Reference is made to your "Fourth" Review of Intention to Commence Large Mining Operations, Basin Perlite Company, Pearl Queen Mine M/001/027, Beaver County, Utah. This Review was dated June 12, 2001.

Reply to Fourth Review of Notice of Intention to Revise Mining Operations, Basin Perlite Company, Pearl Queen Mine M/001/027, Beaver County Utah, Dated June 12, 2001.

EXHIBIT "C"

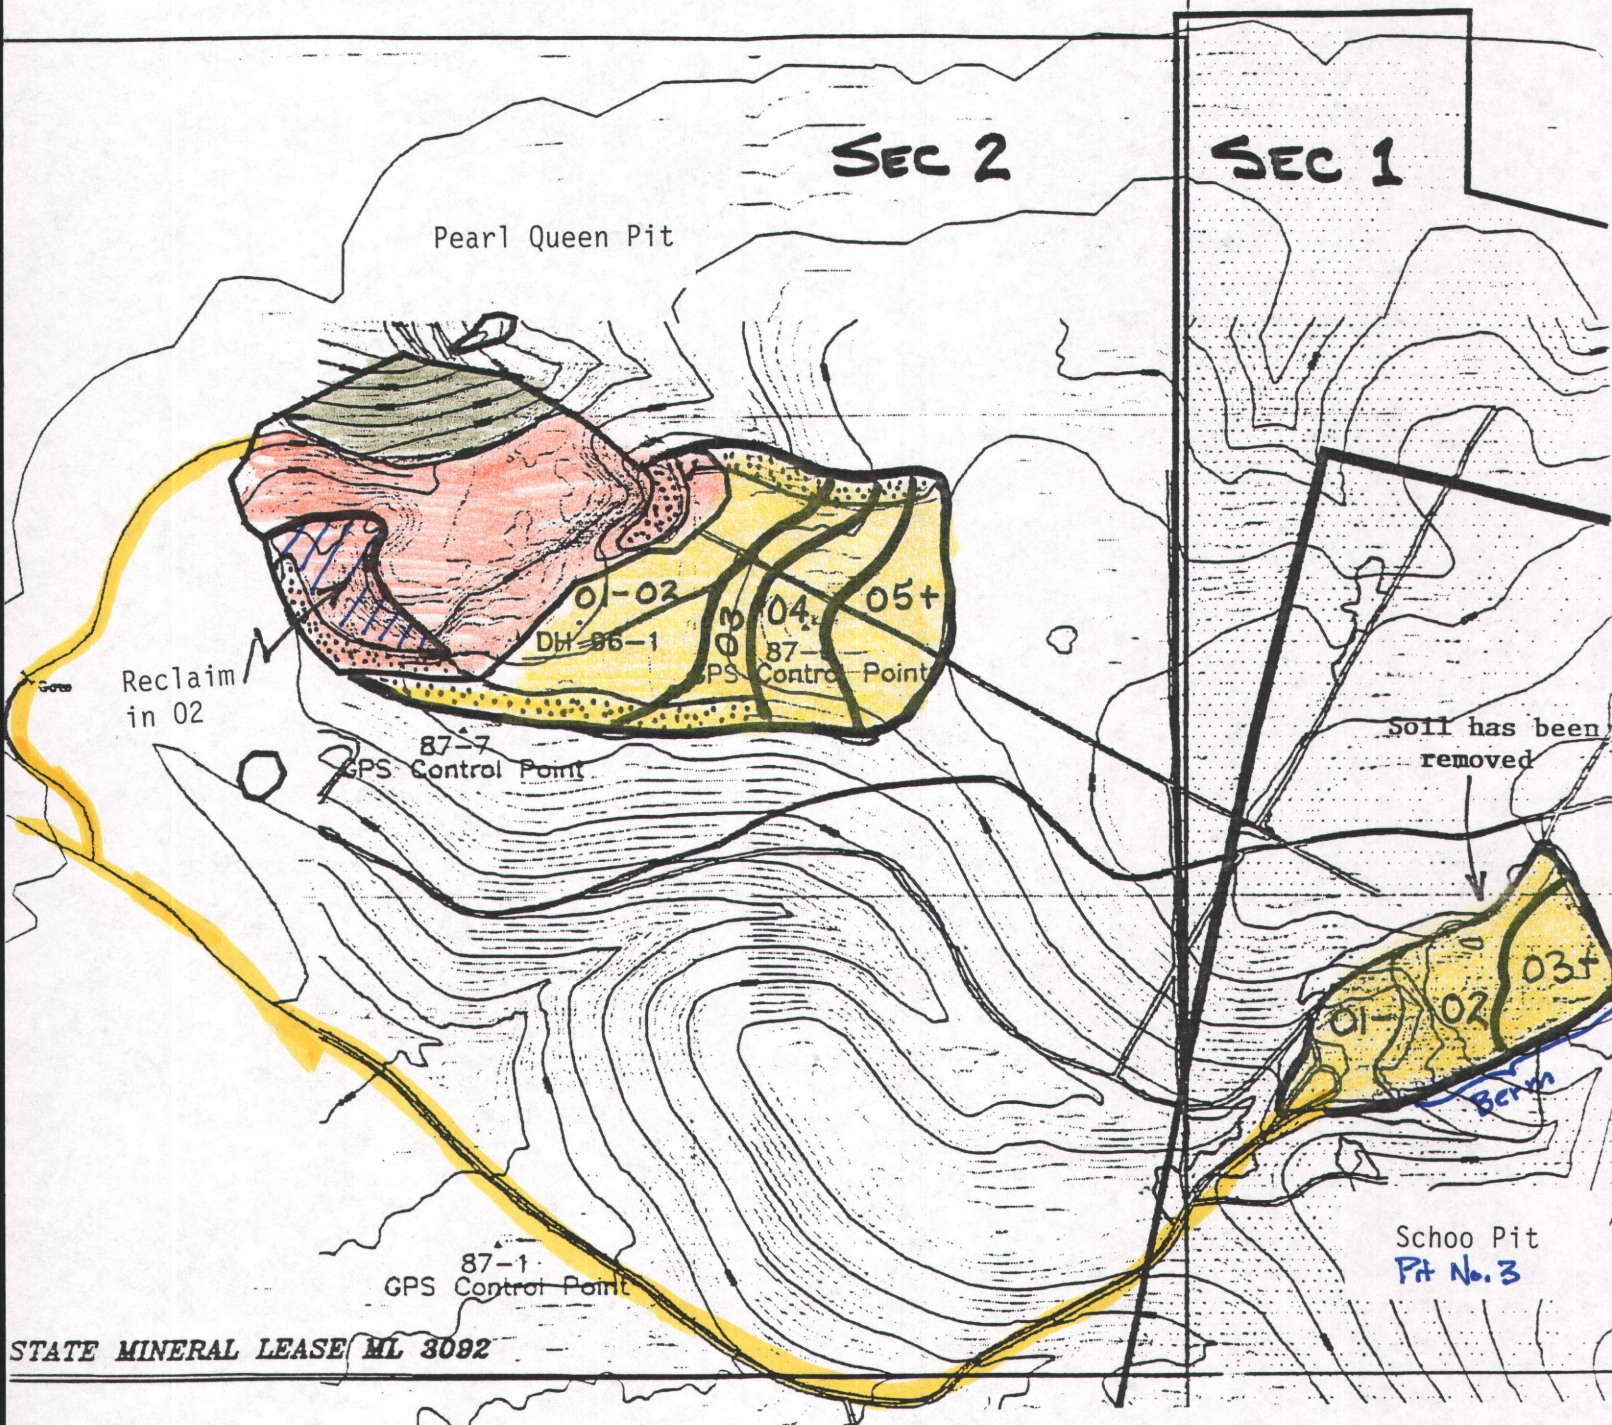
In our reply dated April 13, 2001 we requested a variance in the Schoo Pit area so that reclamation would be complete when 60% of the original vegetation cover has been restored. Our justifications include:

1. There is no soil of any extent present in the proposed mine area. This was verified by the USBLM site visit.
2. Current vegetative cover (naturally restored) is estimated at 40% of cover in adjacent areas.
3. The current site is completely unreclaimed and include a dangerous high wall about 60 feet high. Any reclamation would be a big improvement to the current situation.
